**MONTGOMERY COUNTY DEPARTMENT OF PARK AND PLANNING**

MCPB  
ITEM NO. 13  
06-17-2004

SUBJECT: Montrose Parkway East Phase I Transportation Facility Planning Study  
Project Prospectus Recommendations

**RECOMMENDATION: Transmit the following comments to the Montgomery County Department of Public Works and Transportation (DPWT):**

Figure II-F: Typical Section from Parklawn Drive to just West of Rock Creek Park

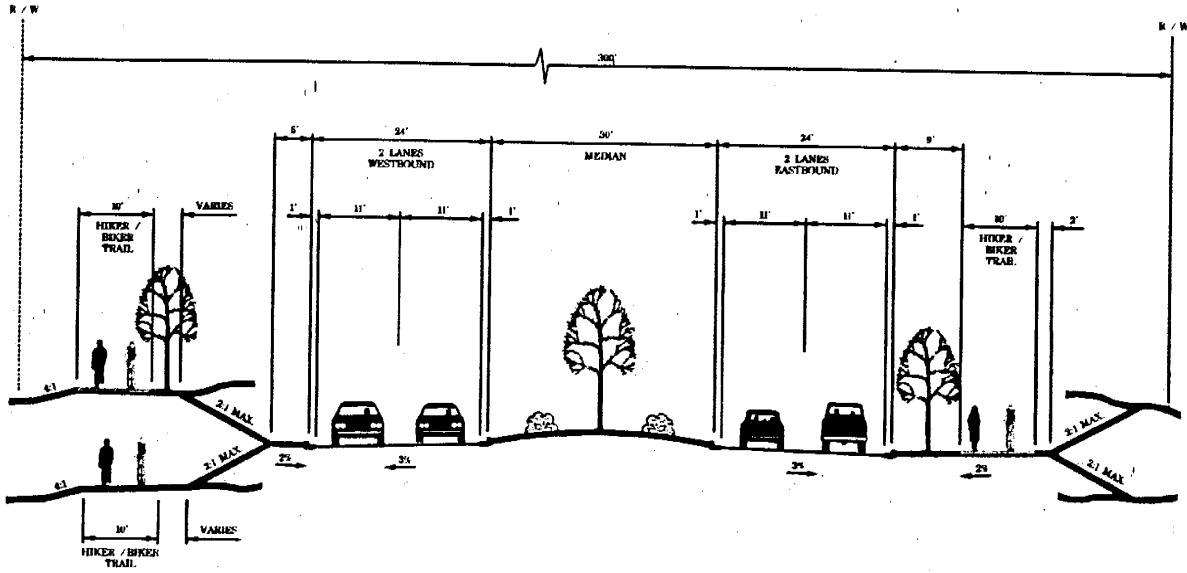
From Parklawn Drive to just west of Rock Creek Park, the Montrose Parkway follows the 300-foot wide right-of-way established in the 1955 Master Plan of Highways for the Outer Circumferential Freeway. This right-of-way is currently owned by SHA. Within this right-of-way, the Montrose Parkway East design features a 30-foot wide landscaped median and a 10-foot wide shared use path (also commonly described as Class I bike paths or hiker-biker trails) on both sides of the roadway.

Figure II-G: Typical Section from just West of Rock Creek Park to Veirs Mill Road

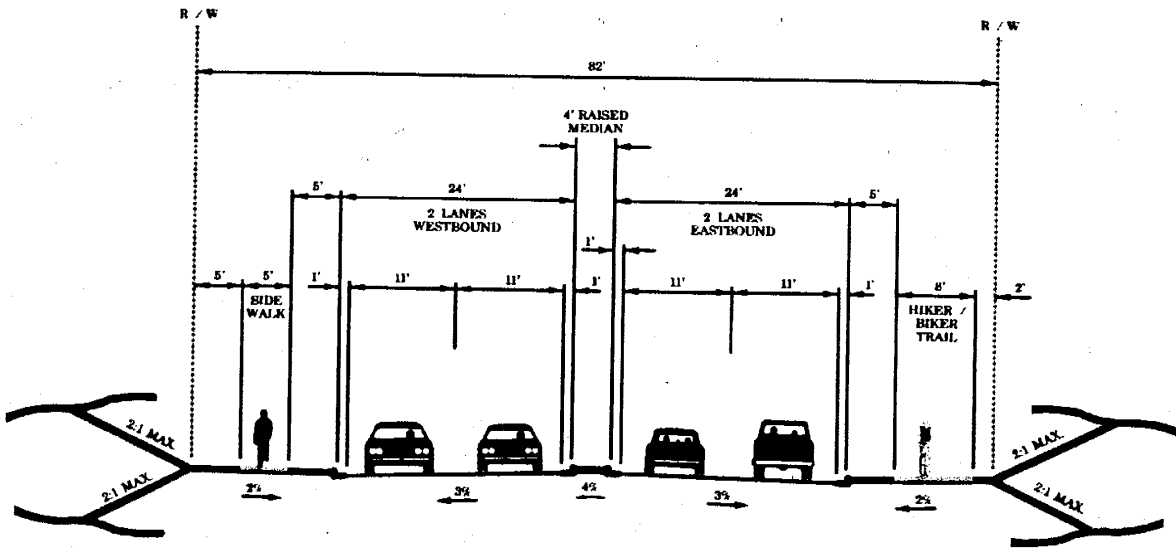
Between the western boundary of Rock Creek Park and Veirs Mill Road, the typical section is reduced to minimize parkland and community impacts. In this typical section the median is narrowed to a four-foot wide raised median, the shared use path on the south side of

the roadway is reduced to eight feet in width, and the pedestrian accommodation on the north side of the roadway is reduced to a five-foot wide sidewalk.
